ATTACHMENT 5

Letter from M. E. Warner (NMC)

License Amendment Request 187

Revised Pages for Updated Safety Analysis Report
(USAR)

Figure 14.1.1-1

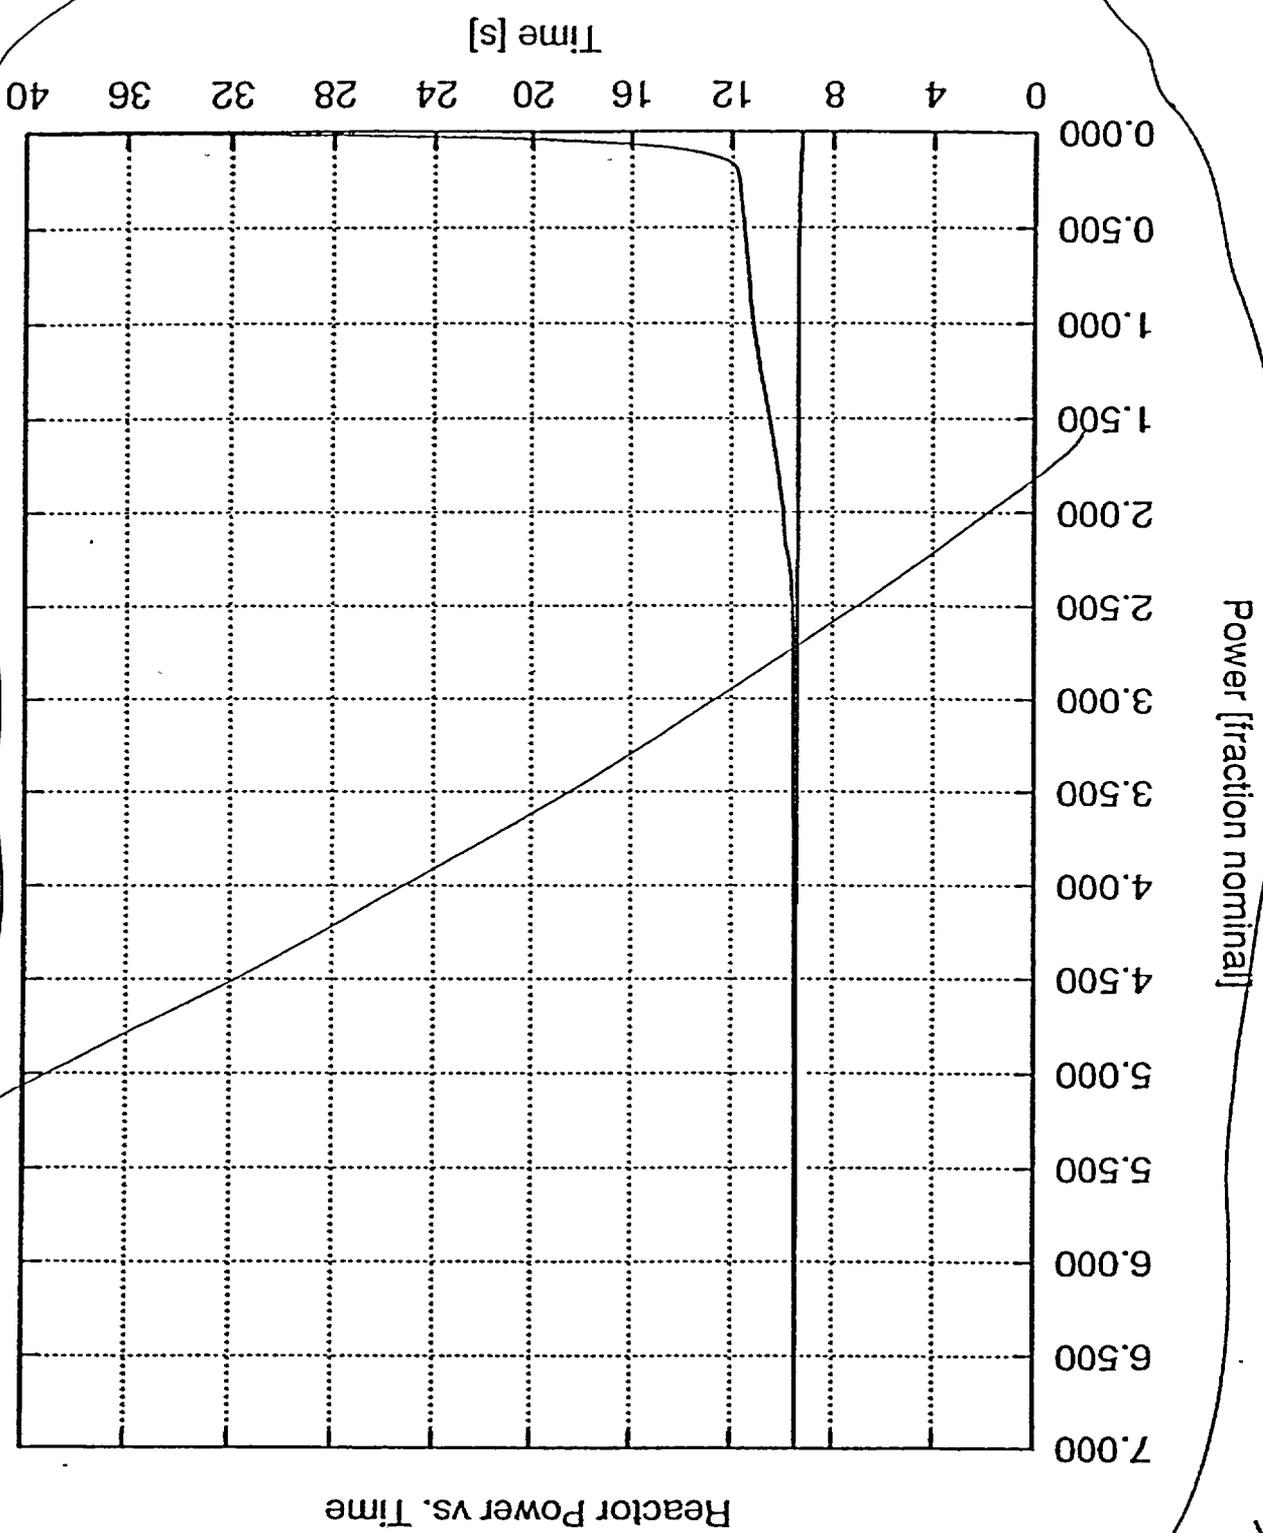
Replace with new Fig 14.1.1-1

Figure 14.11-2
Rev. 16
12/01/2000

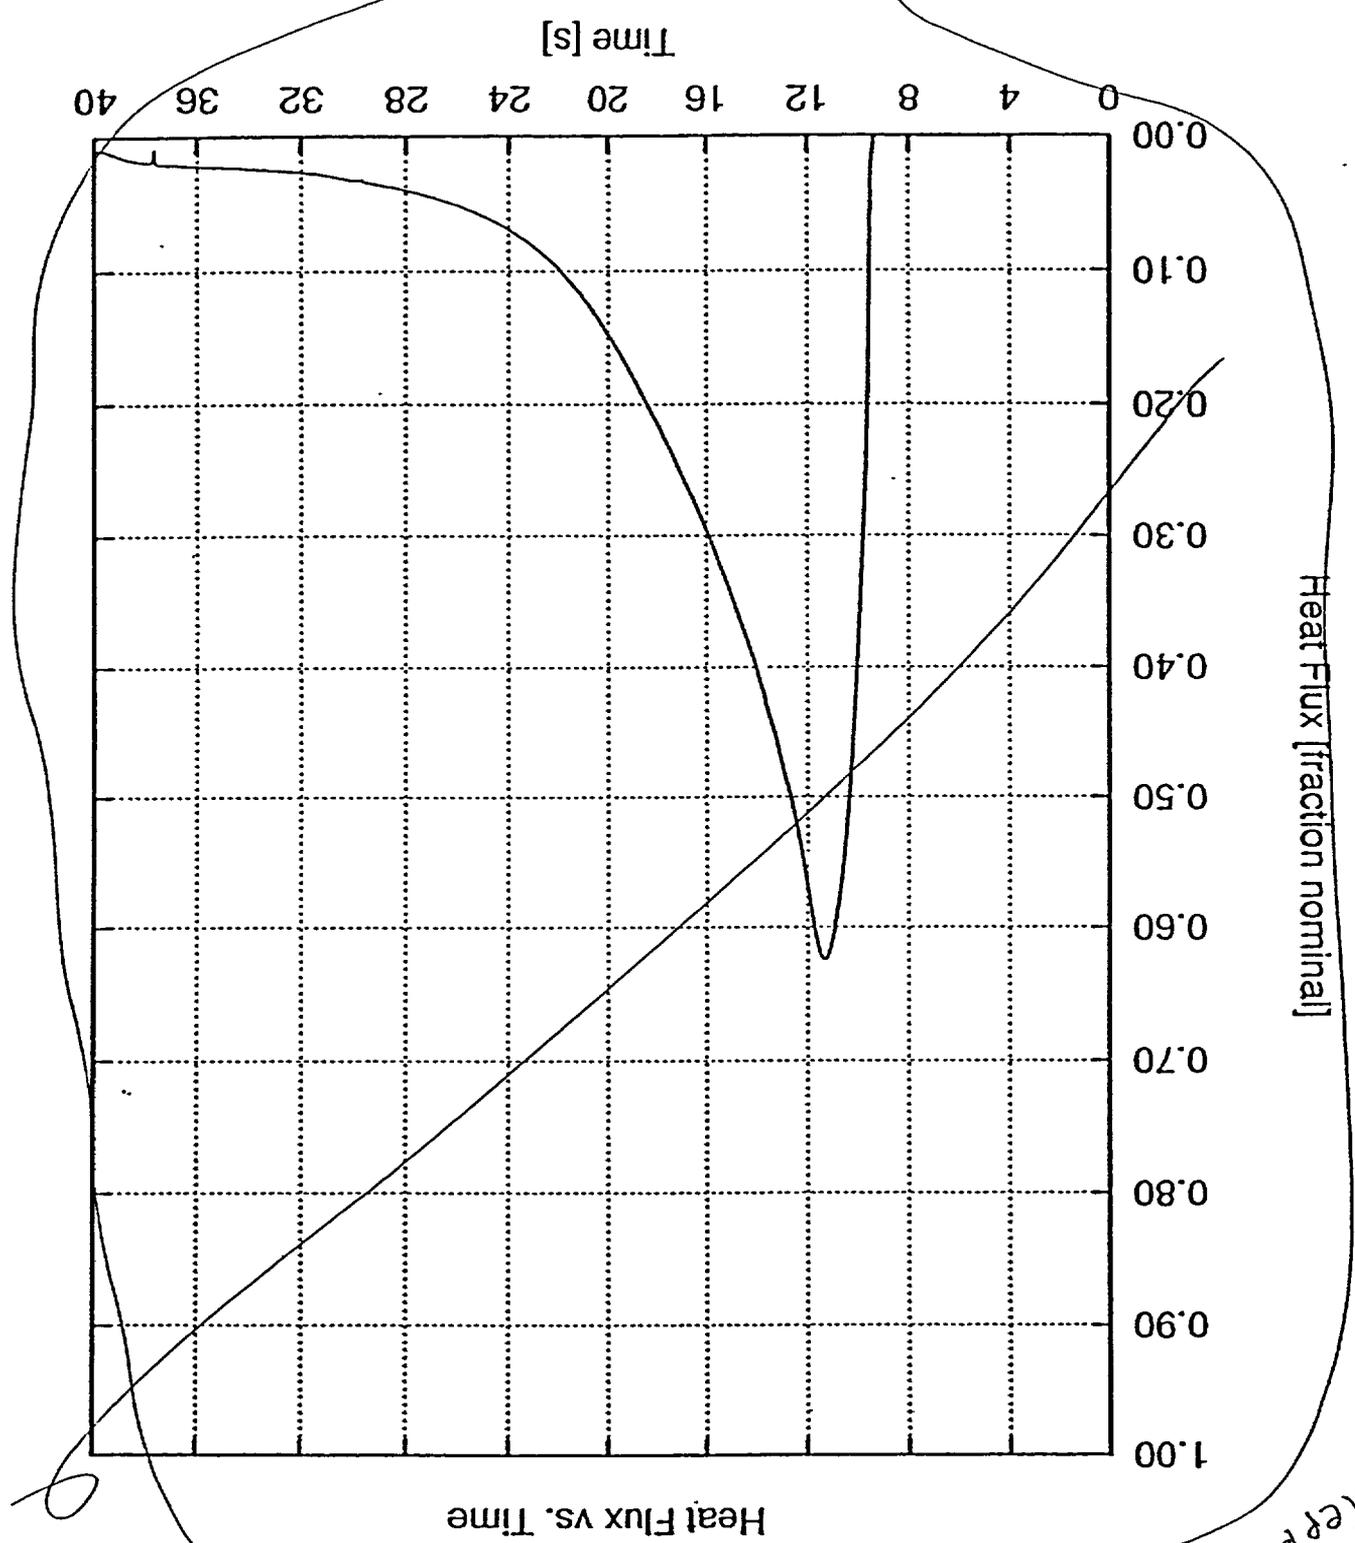
Replace with new Fig. 14.11-2

Figure 14.1.1-3

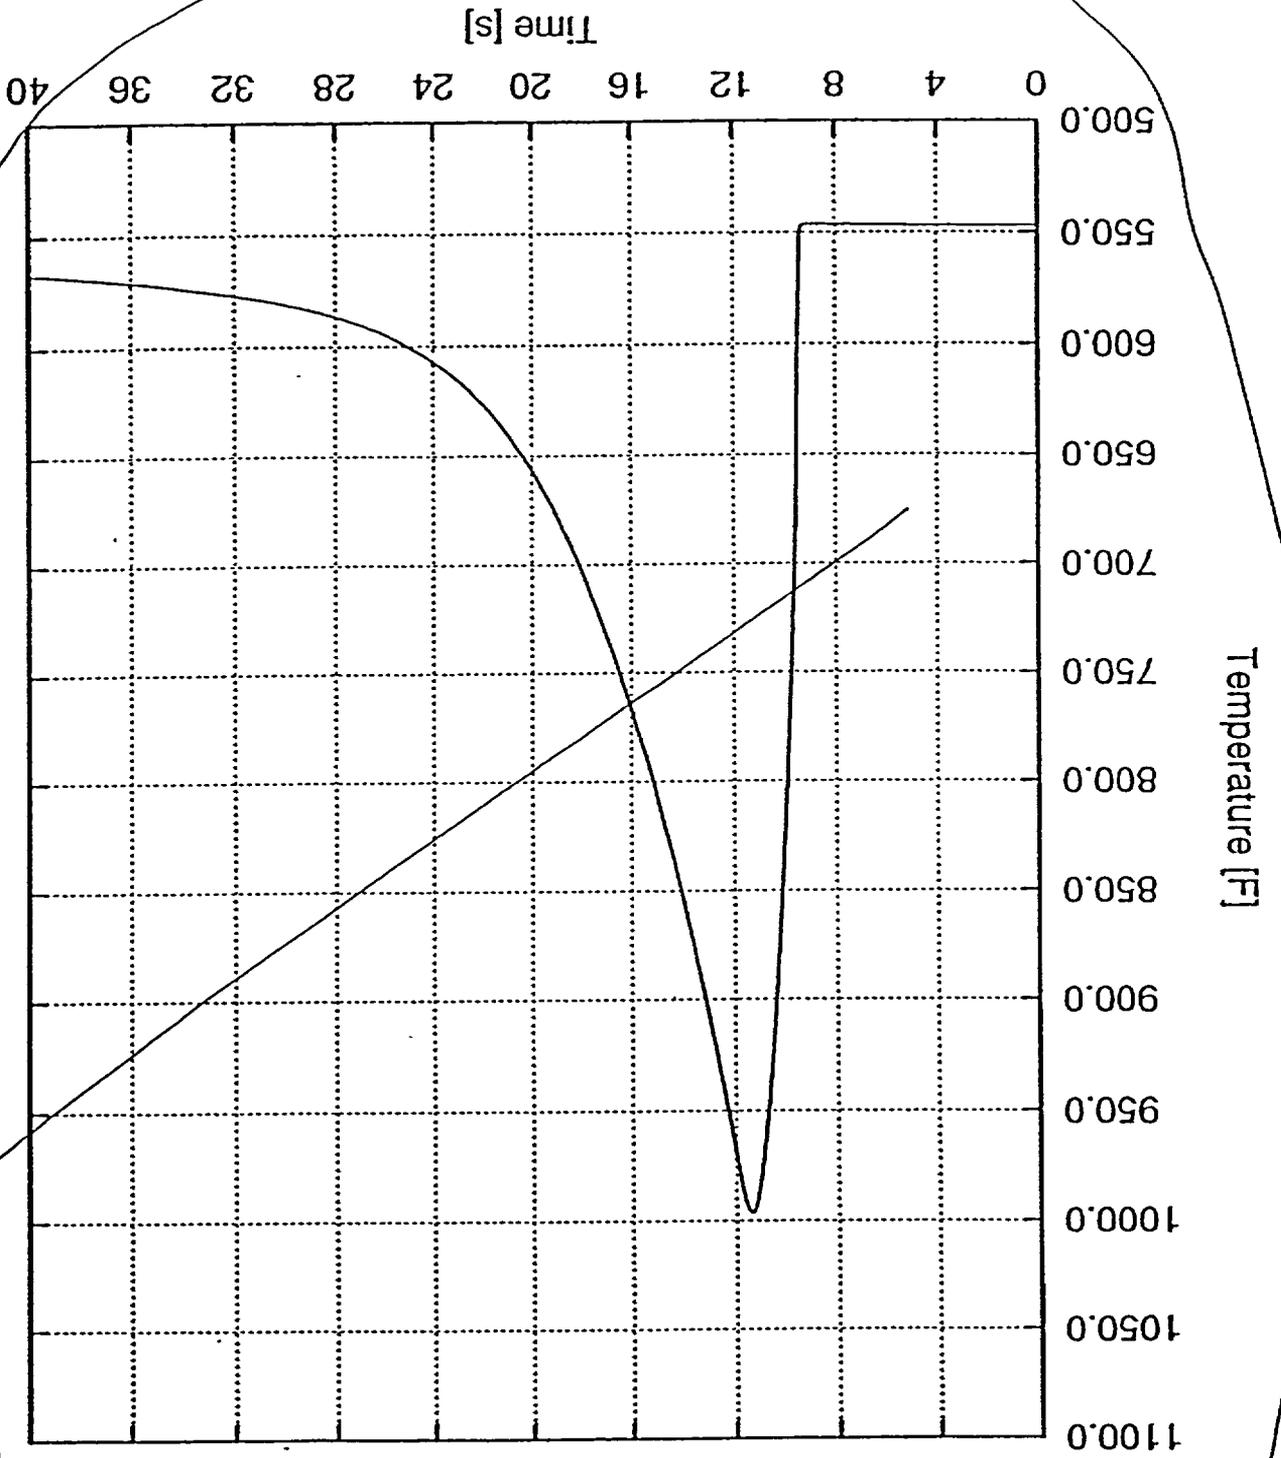
Replace with new Fig. 14.1.1-3

Figure 14.1.1-4

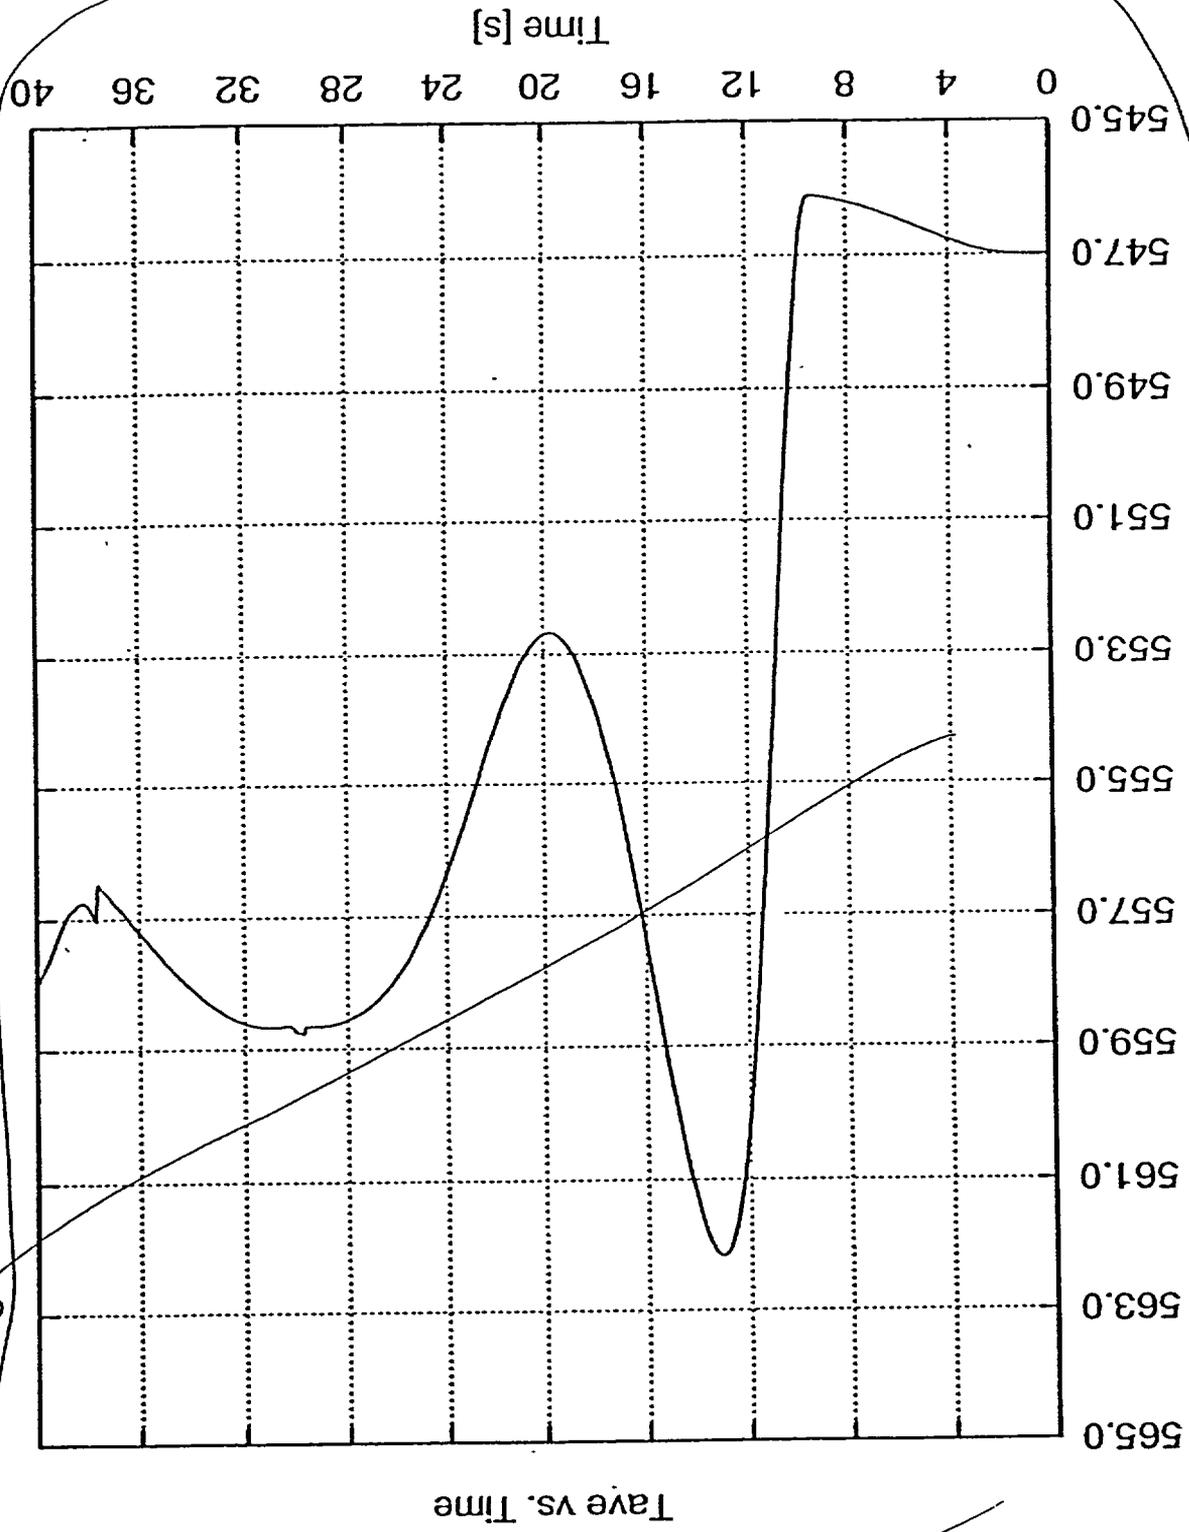
Replace with new Fig 14.1.1-4

Figure 14.1.1-5

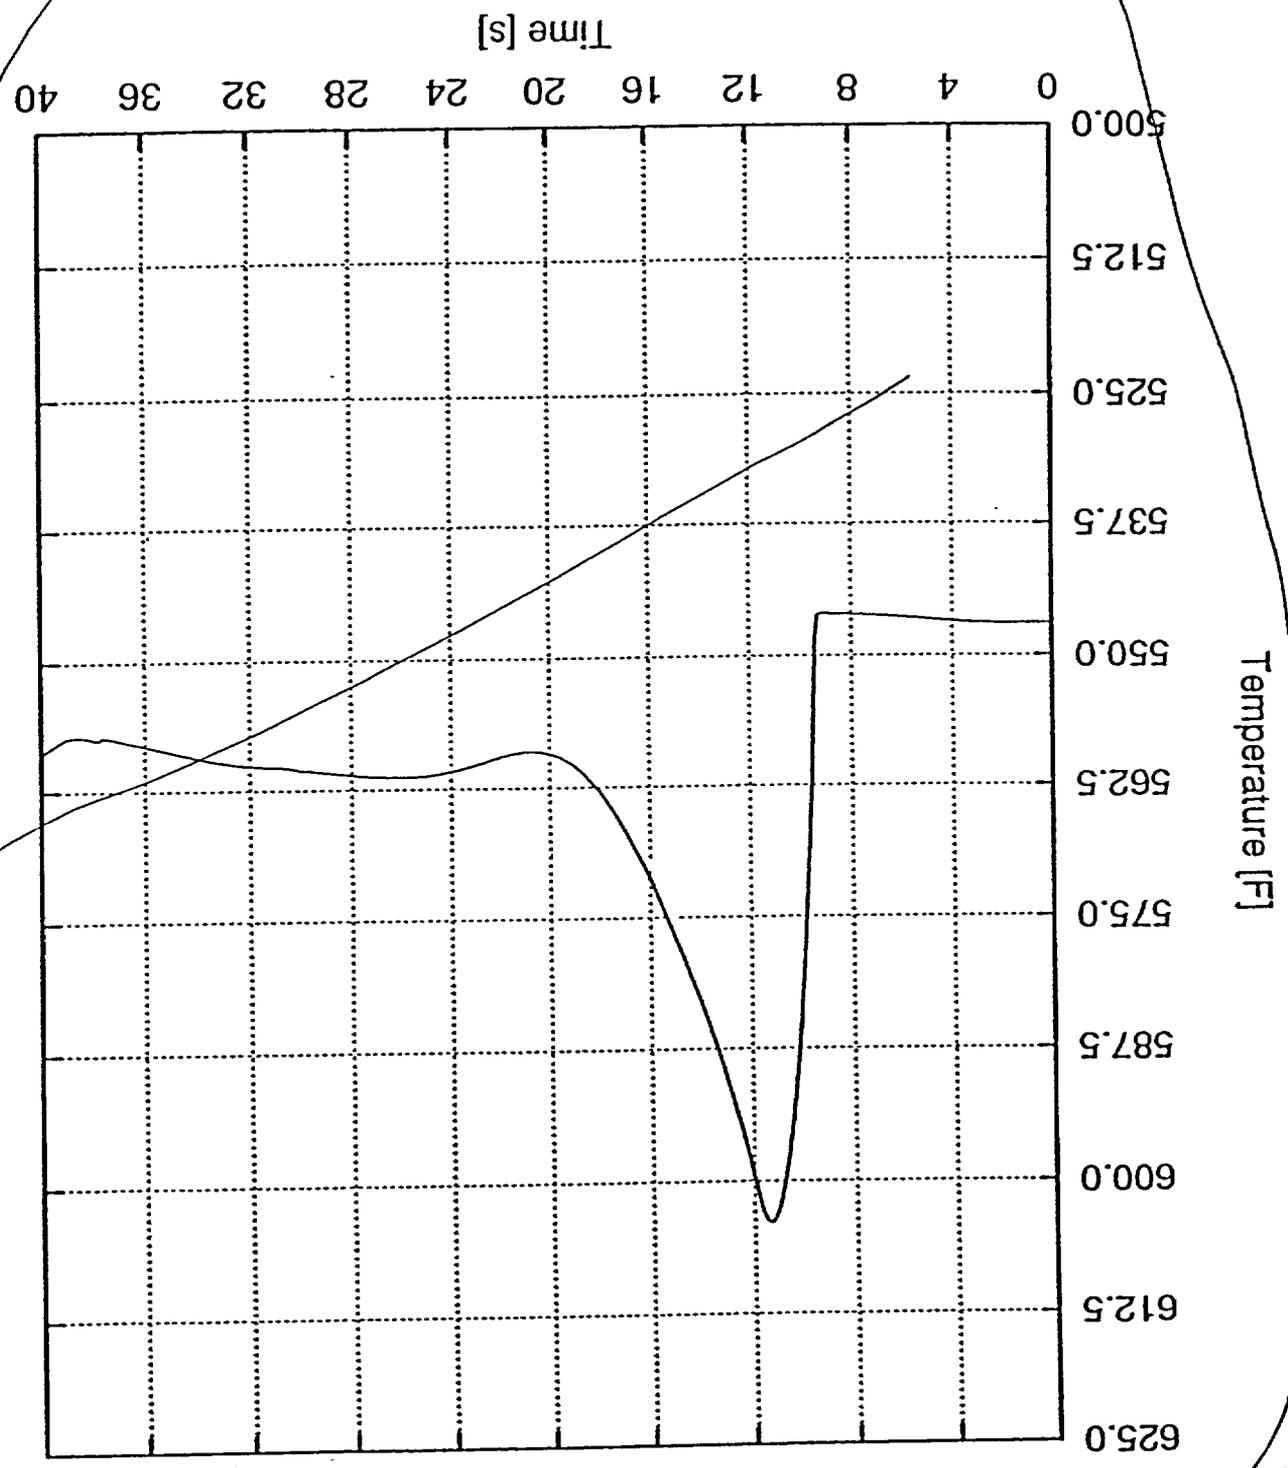
Replace with new Fig 14.1.1-5
